# HISTORIC AND DESIGN REVIEW COMMISSION

June 05, 2019

**HDRC CASE NO:** 2019-281  
**ADDRESS:** 6860 RAINTREE PATH  
**LEGAL DESCRIPTION:** NCB 16587 BLK LOT P-10A (DRAINAGE ROW) "RAINTREE"  
ANNEXATN  
**ZONING:** R-6  
**CITY COUNCIL DIST.:** 10  
**APPLICANT:** Marc Zak/Terra Design Group  
**OWNER:** CITY OF SAN ANTONIO  
**TYPE OF WORK:** Park Improvements  
**APPLICATION RECEIVED:** May 17, 2019  
**60-DAY REVIEW:** July 16, 2019  
**CASE MANAGER:** Adam Rajper  
**REQUEST:**

The applicant is requesting a Certificate of Appropriateness to carry out various park improvements.

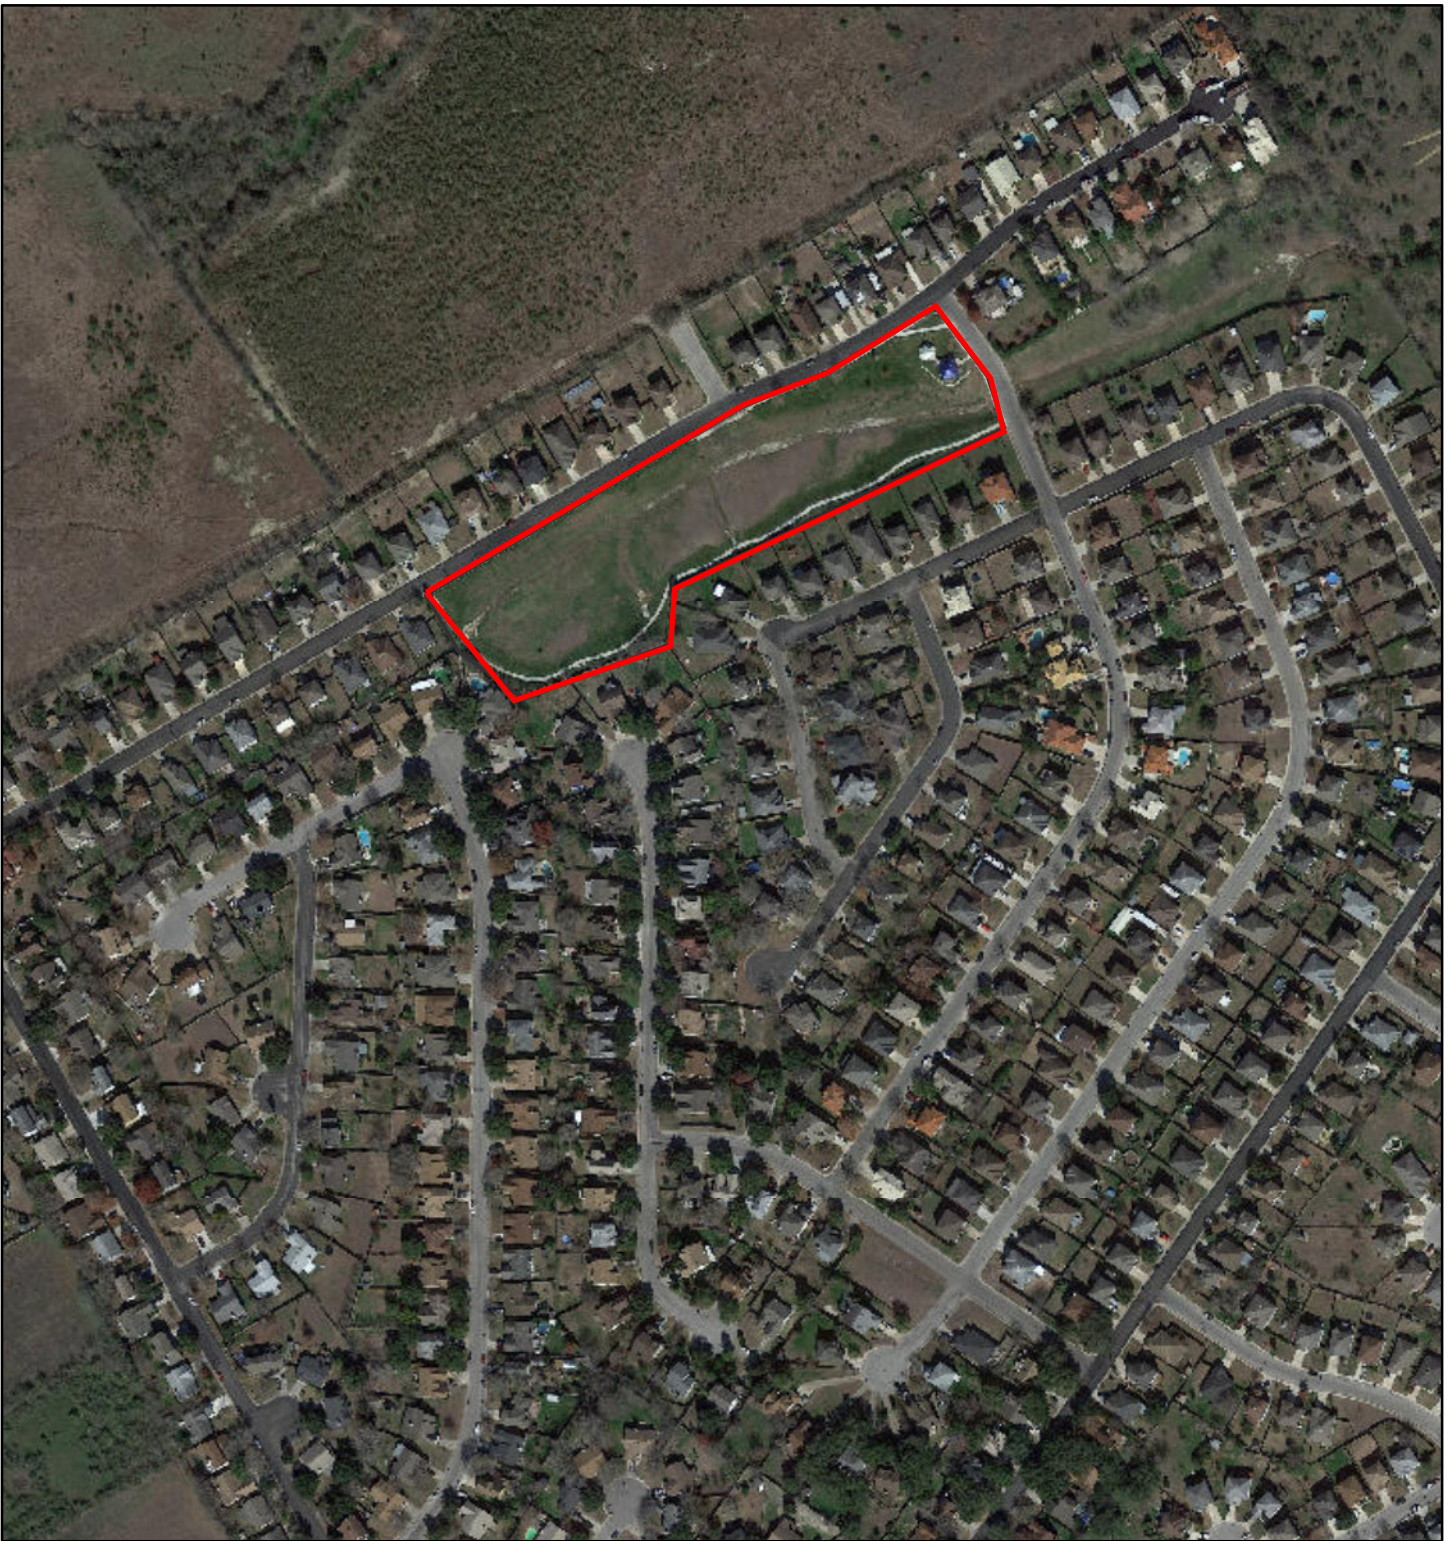
- a. The property located at 6860 Raintree Path, northeast of Downtown, is a public park with the common name of Raintree Park. The applicant is requesting approval for various park improvements.
- b. PARK IMPROVEMENTS – The applicant is requesting approval to install new playground equipment (swing), a shade canopy for the new playground equipment, playground safety surfacing, limestone block landscape walls in the playground area, and an Americans with Disabilities Act (ADA) accessible concrete walkway connecting the existing pavilion area to the playground, two picnic areas along the exiting trail (each to include a picnic table with trash/recycle receptacles), and site lighting. Staff finds the proposal consistent with the UDC.
- c. ARCHAEOLOGY – The project shall comply with all federal, state, and local laws, rules, and regulations regarding archaeology.

Staff recommends approval of the proposed park improvements based on findings a through c with the following stipulation:

- i. ARCHAEOLOGY – The project shall comply with all federal, state, and local laws, rules, and regulations regarding archaeology.
